WALNUT GROVE VILLAGE TWIN CHIMNEYS

VILLAGE G

STORM & SANITARY SEWER MEASUREMENTS

VOLZ 88-2860

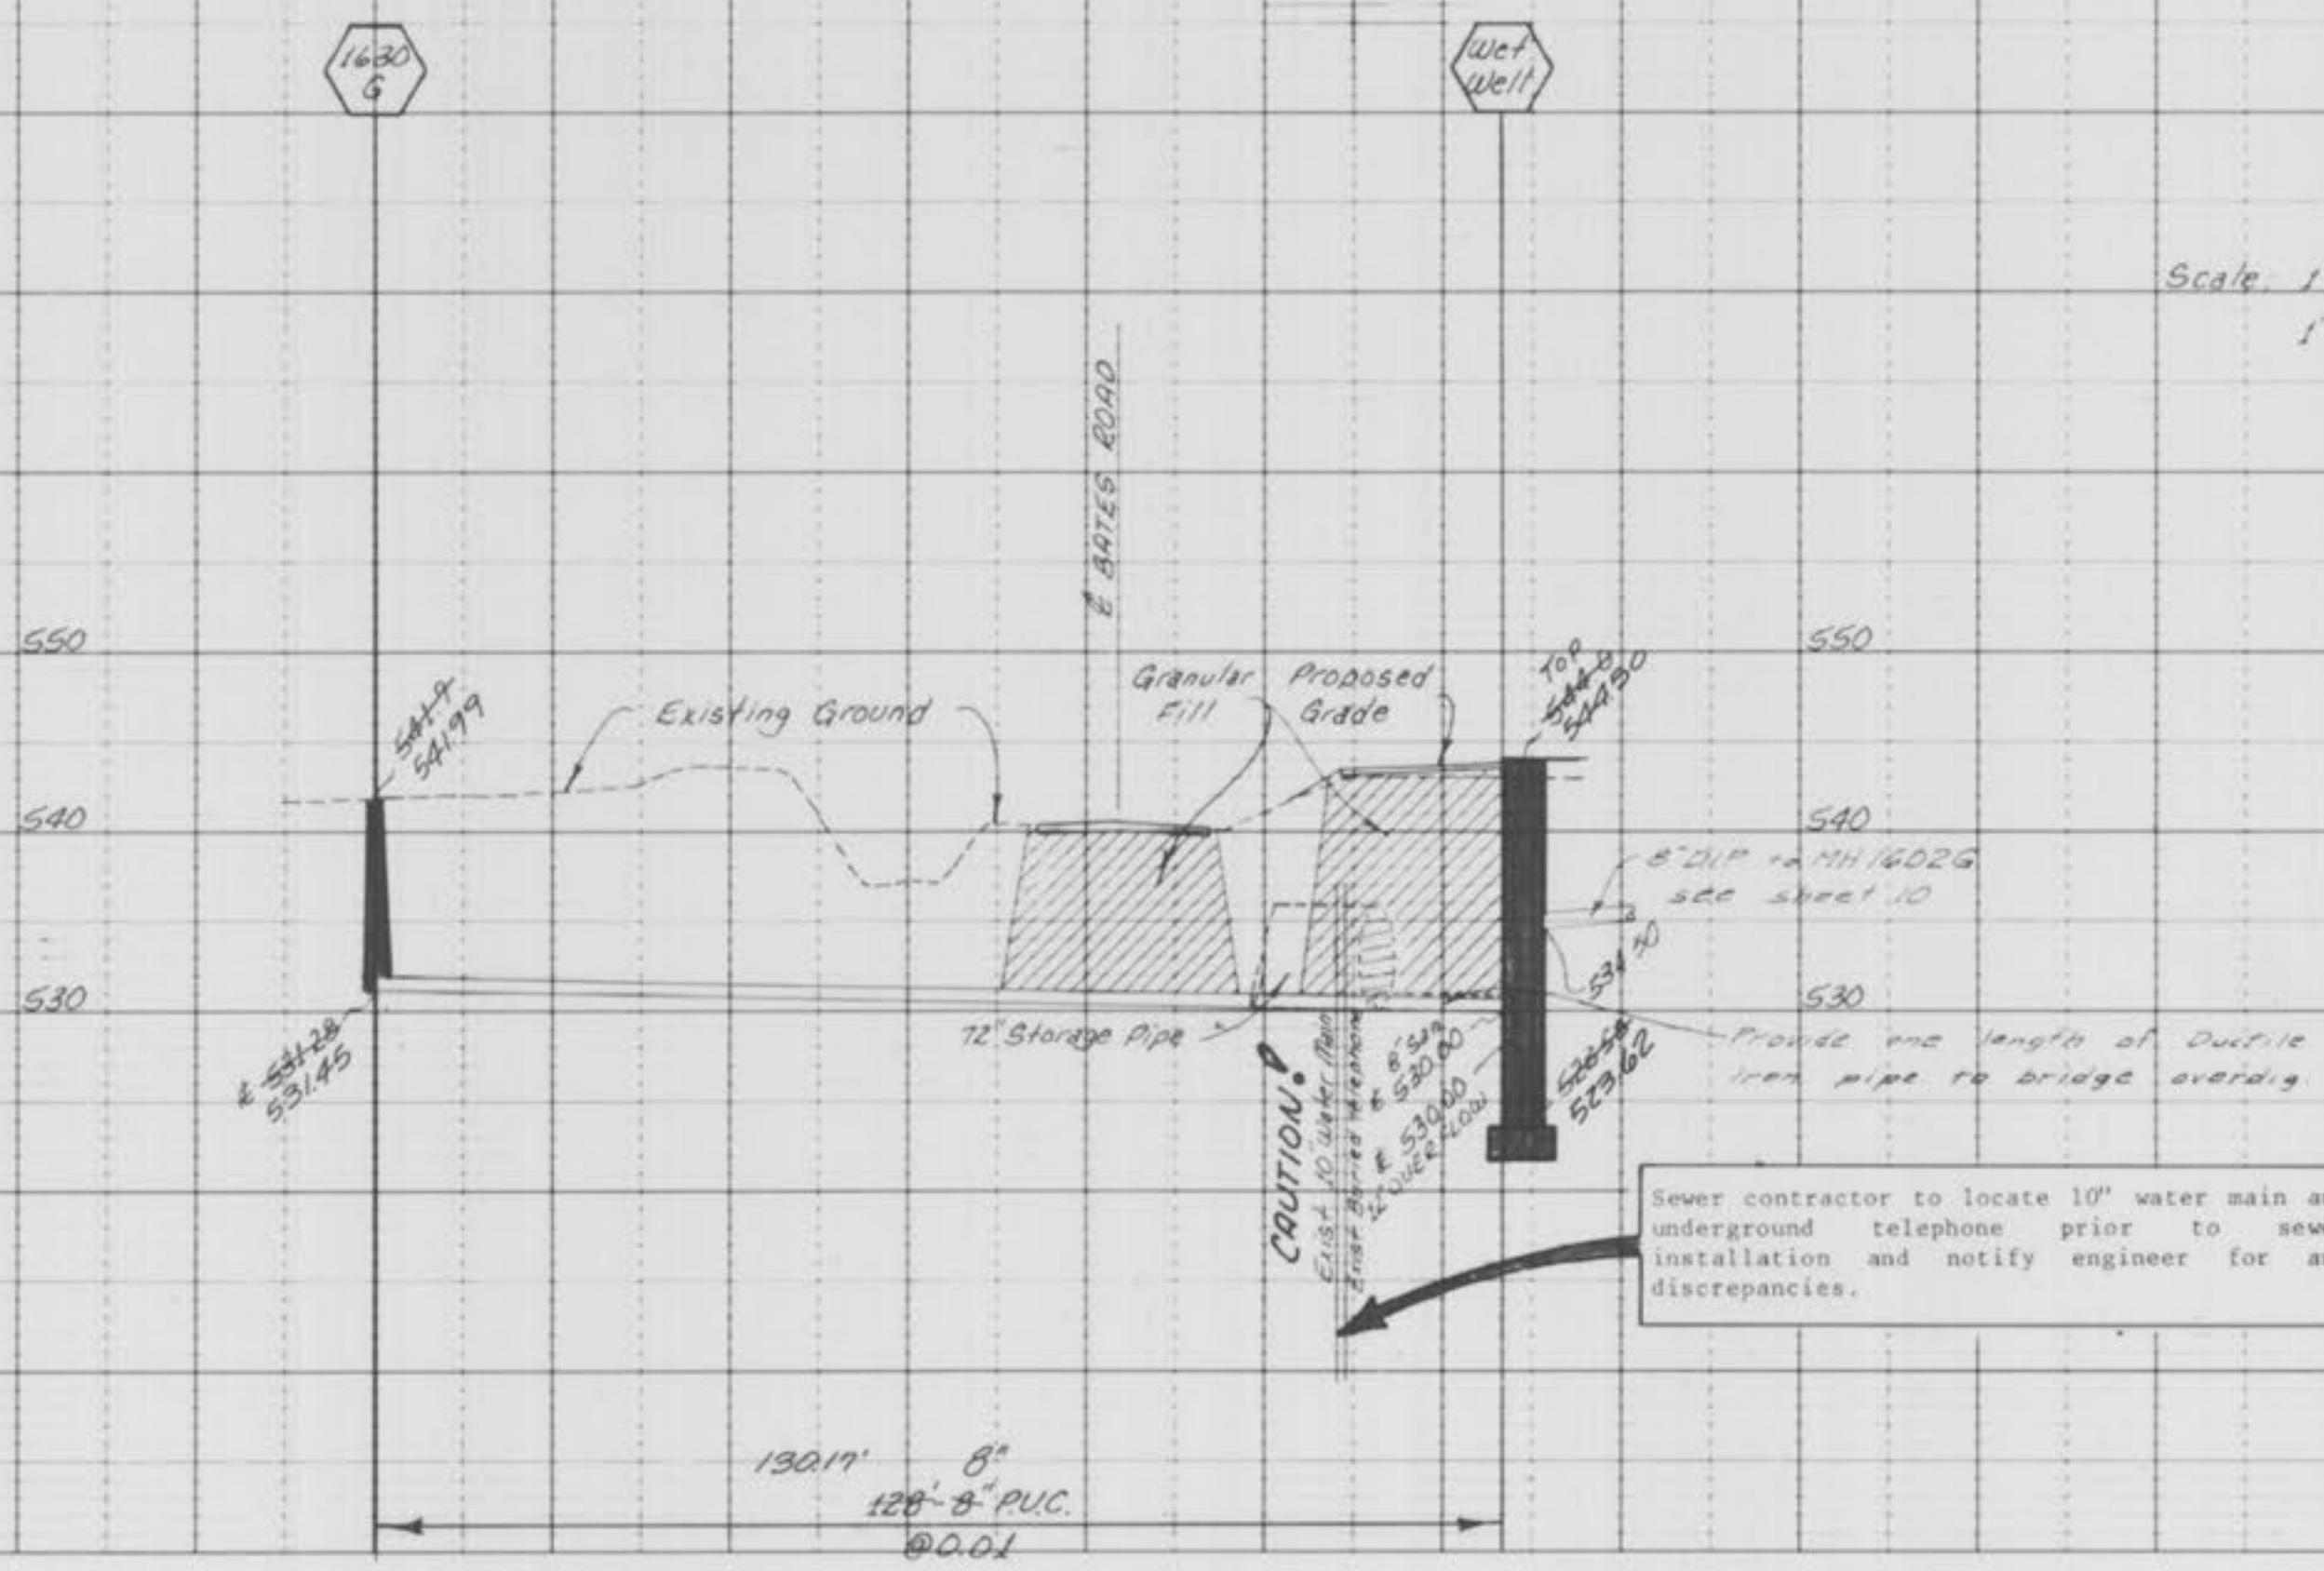
We have measured the existing sewer lengths, sizes, flowlines, depths of structures and the results of these measurements are shown on this plan by lining out the planned number and indicating the measured number adjacent to the planned number. All other numbers have not been measured or verified.

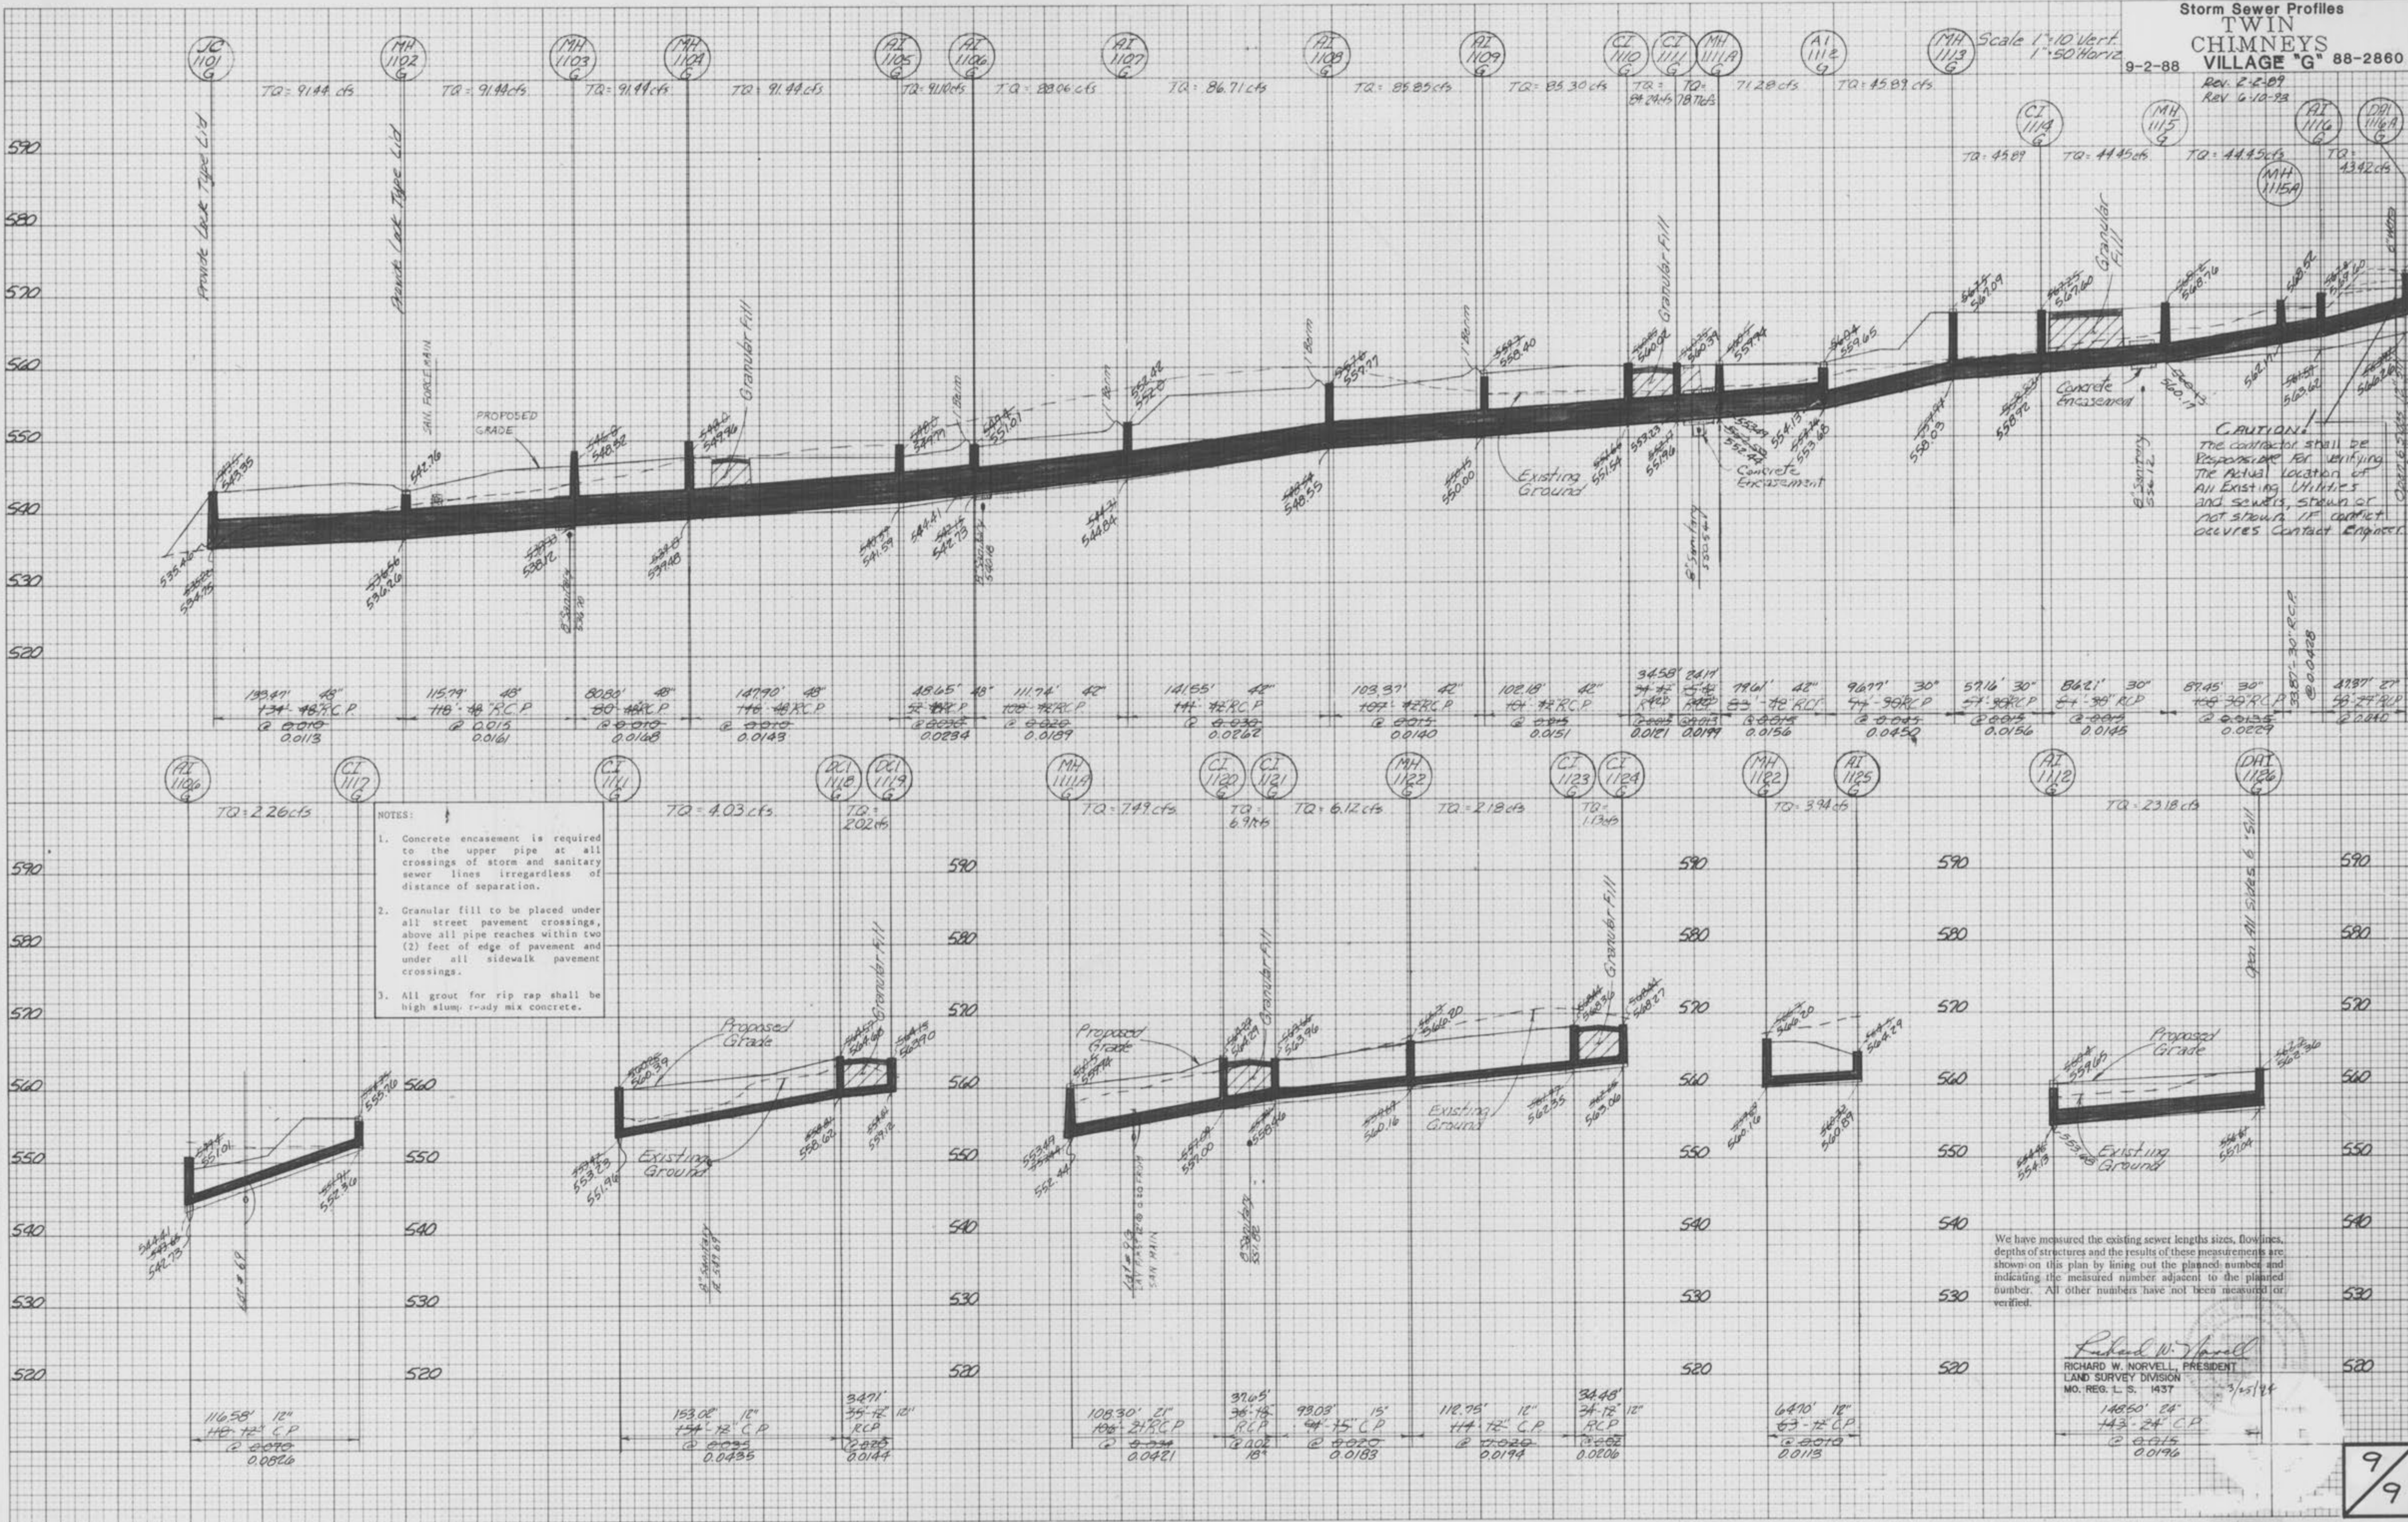
We have measured the existing sewer lengths, sizes, flowlines, depths of structures and the results of these measurements are shown on this plan by lining out the planned number and indicating the measured number adjacent to the planned number. All other numbers have not been measured or verified.
